CITY OF NEWTON
ENGINEERING DIVISION

MEMORANDUM

Re: Special Permit – 22-25 Beecher Terrace

Proposed 5 Units
22 & 26 Beecher Terrace
Newton, MA
Prepared by: Greater Boston Surveying & Engineering
Dated: March 25, 2013

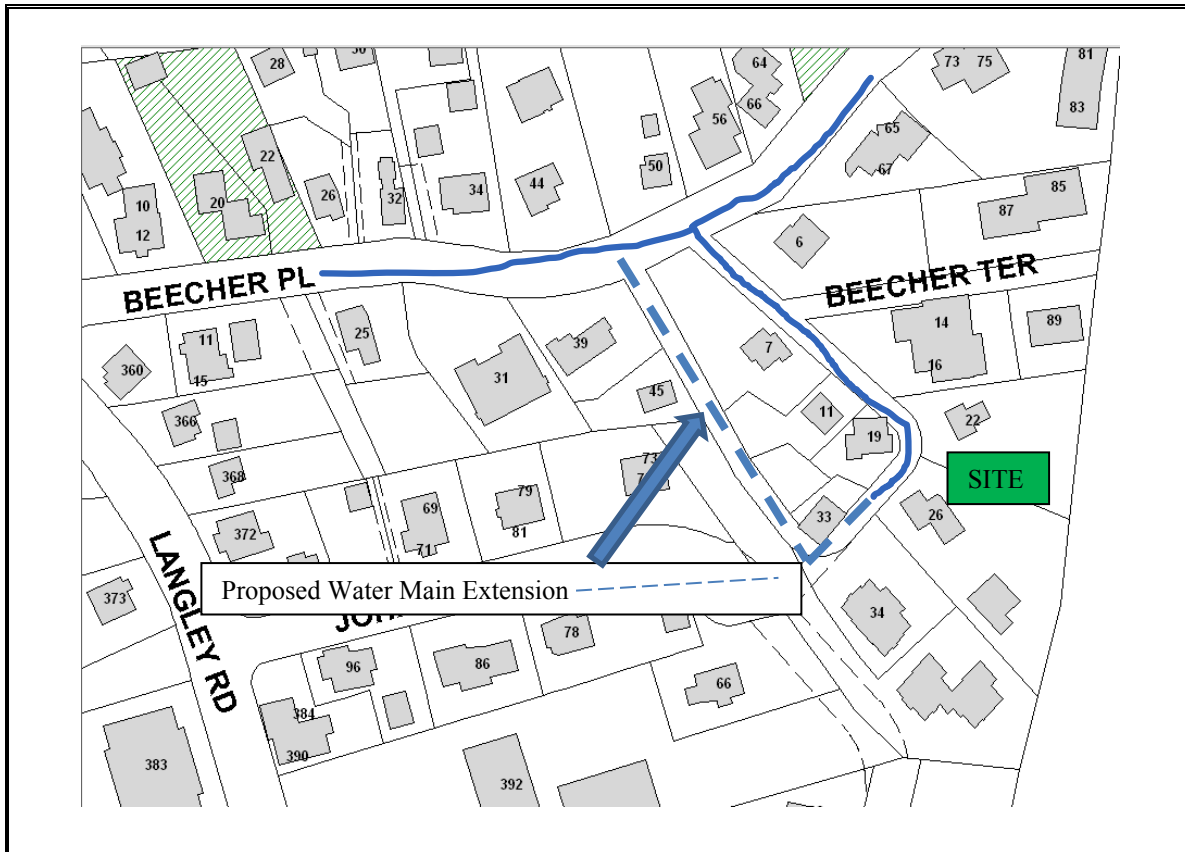
A retaining wall greater than 4' is proposed parallel to the southern property line, however; no indication of the wall height is referenced. Walls over 4' will need a safety fence.

As a Public benefit, the two concrete aprons that are totally destroyed at the Beecher Place & Beecher Terrace intersections should be replaced, and Beecher Terrace should be repaved. The proposed 10" CLDI pipe is not acceptable because the existing main in Beecher Place is only 6" main. However, the Director of Utilities has indicated that the main in Beecher Terrace is a dead end main and should ideally be looped back to Beecher

Place along the southerly leg of Beecher Terrace; this will be a water quality and quantity improvement and a public benefit. (See below).

Finally, the plans submitted are not to correct scale this need to be corrected, furthermore; the plans are not very clear.

1. The engineer of record shows on site drainage improvements, however; no calculations or drainage report received at the time of this review. On site soil testing is required for the evaluation of the proposed drainage system. Test pits and percolation test(s) are required within 20-feet of each system, to verify groundwater elevations, and soil types.

2. There is a proposed overflow pipe directing overflow stormwater towards the abutting property to the east towards Chestnut Hill Condominiums; this is not acceptable since the flow condition is being altered from the existing condition as [sheet flow] to the proposed condition as a [point source] discharge. To remedy this situation the flared end section should be directed to an underground diffuser comprised of a perforated pipe embedded in washed crushed stone and filter fabric, and having an impervious barrier on the downstream side of the system.

3. The proposed overflow pipe from the driveway at unit # 1 to the catch basin in Beecher Terrace is not permitted. The engineer of record needs to demonstrate why the overflow is warranted and why the runoff from the site cannot be completely contained on-site.

7. The proposed dry well details need to specify “**crushed washed stone**”. The elevation of the bottom of the stone, bottom of the pipe and depth to groundwater table need to be labeled. A detail is needed with filter fabric - 3” layer of peastone on top of the system, and then covered over with filter fabric.
